Amendments to the Drawings

10/685,872 MEG-02-015

REMARKS

FIG 3a

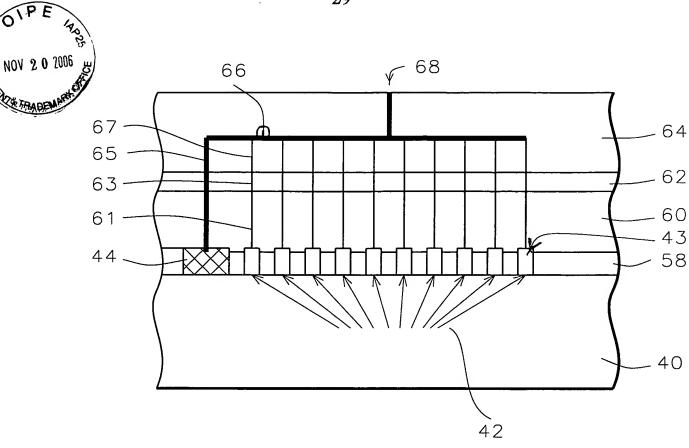
Figs. 3a, 3b, and 3c have been amended to include an arrow point on the reference line 43. Fig. 3a has been amended to extend reference line 66. Fig. 3b has been amended to extend reference lines 66 and 65. Fig. 3c has also been amended to identify passivation layer 62, as in Figs. 3a and 3b. Fig. 3c has also been amended to show an opening to the aluminum metal 61' as described in the first full paragraph on page 24, and in the paragraph bridging pages 15 and 16, and as shown in Figs. 6c and 6d. A missing line between layers 58 and 60 has been added.

FIG. 4α

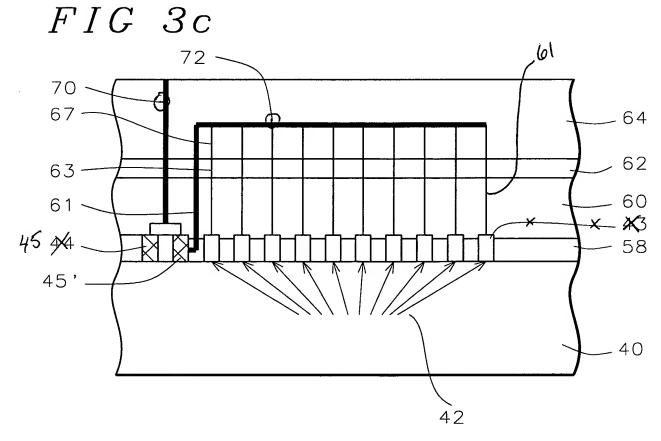
Fig. 4a has been amended to remove the reference number 43. 43 is a power or ground node. Fig. 4a addresses signals, as described in the paragraph bridging pages 24 and 25, not power or ground voltages. Fig. 4a has also been amended to replace 44 with 45, as shown in Fig. 4b. A reference number 61 has also been added to the right side of the figure. The reference lines 70 and 72 have been extended.

FIG 4b

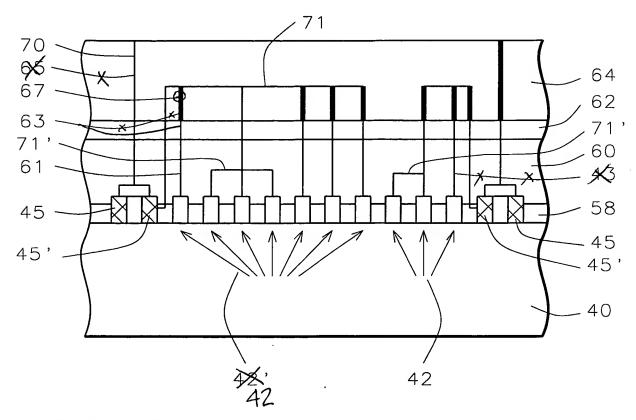
Fig. 4b has been amended to correct the positioning of the line for reference numbers 63 and 67, as shown in Fig. 4c. The prime has been deleted from 42 to be consistent with Figs. 4a and 4c. 43 has been removed, as discussed above. Duplicate reference number 65 has been removed.

FIG. 4c

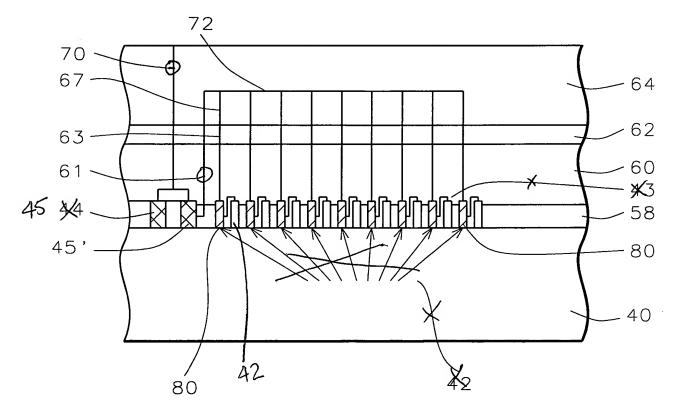
Fig. 4c has been amended to replace 44 with 45, as shown in Fig. 4b. Fig. 4c has also been amended to correct 42 to point to one of the circuits next to an intra-chip driver or receiver 80. 43 has been removed, as discussed above. Reference lines 61 and 70 have been extended.

FIG 4d

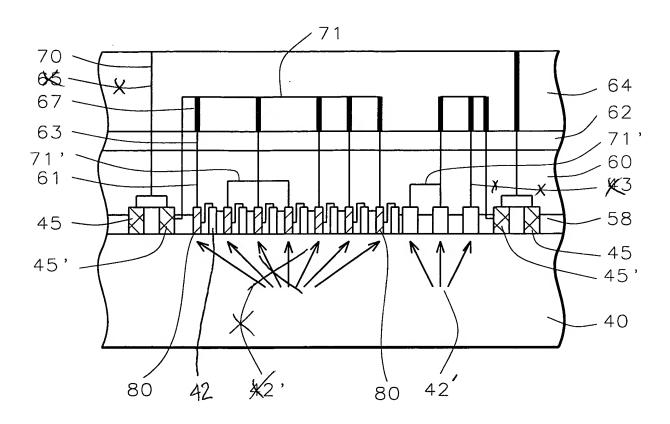
Fig. 4d been amended to correct 42 to point to one of the circuits next to an intra-chip driver or receiver 80 and to show 42' on the right side of the figure. 43 has been removed, as discussed above. Duplicate reference number 65 has been removed.

FIG. 5α

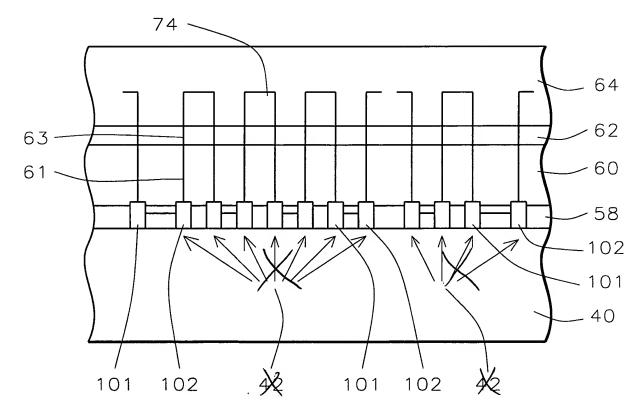
Fig. 5a has been amended to remove reference number 42 which is not part of this figure. This figure shows driver/receivers, transceivers, or repeater devices 101 and 102, as described in the paragraph bridging pages 29 and 30.

FIG 5b

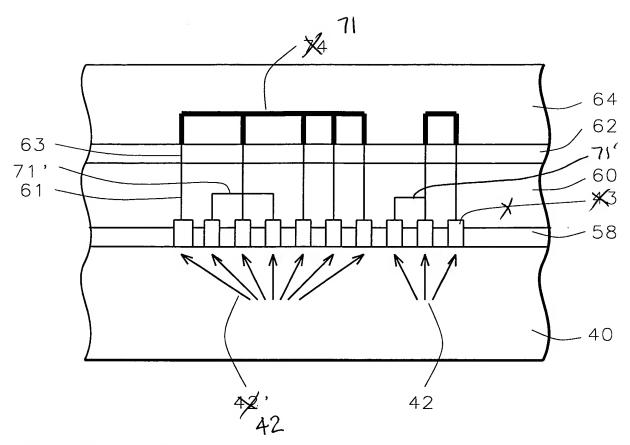
Fig. 5b has been amended to refer to the lines in layer 64 as 71 and the lines in layer 60 as 71', as described in the last paragraph on page 30. A reference line 71' has been added to the right side of the figure. Fig. 5b has also been amended to replace 42' with 42. 43 has been removed as discussed above.

FIG. 5c

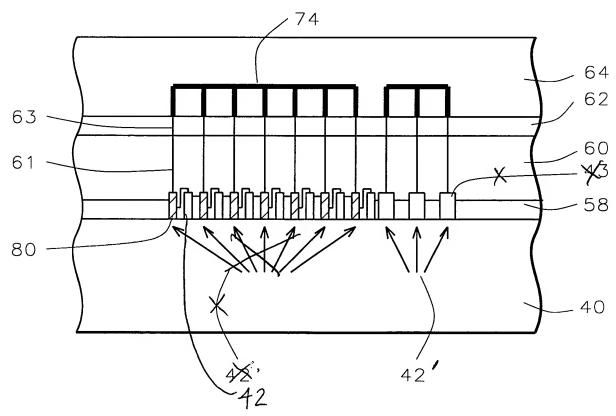
Fig. 5c has been amended to show 42' on the right side of the figure and to correct 42 to point to one of the circuits next to an intra-chip driver or receiver 80. 43 has been removed as discussed above.

FIG 5d

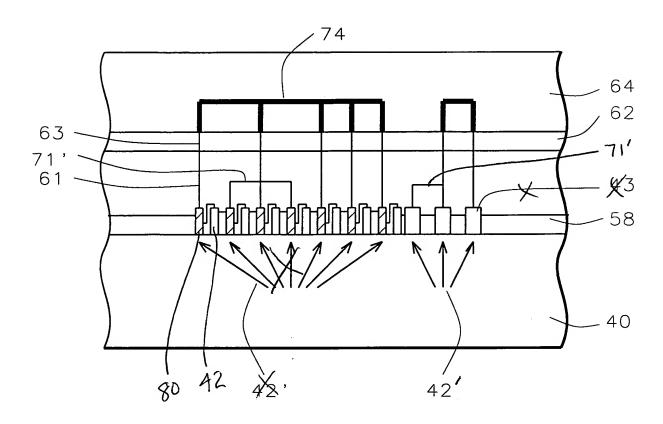
Fig. 5d has been amended to show 42' on the right side of the figure and to correct 42 to

point to one of the circuits next to an intra-chip driver or receiver 80, as shown in amended Figs.

4c and 5c. A reference number 71' has been added to the right side of the figure, as in Fig. 4d.

43 has been removed as discussed above.
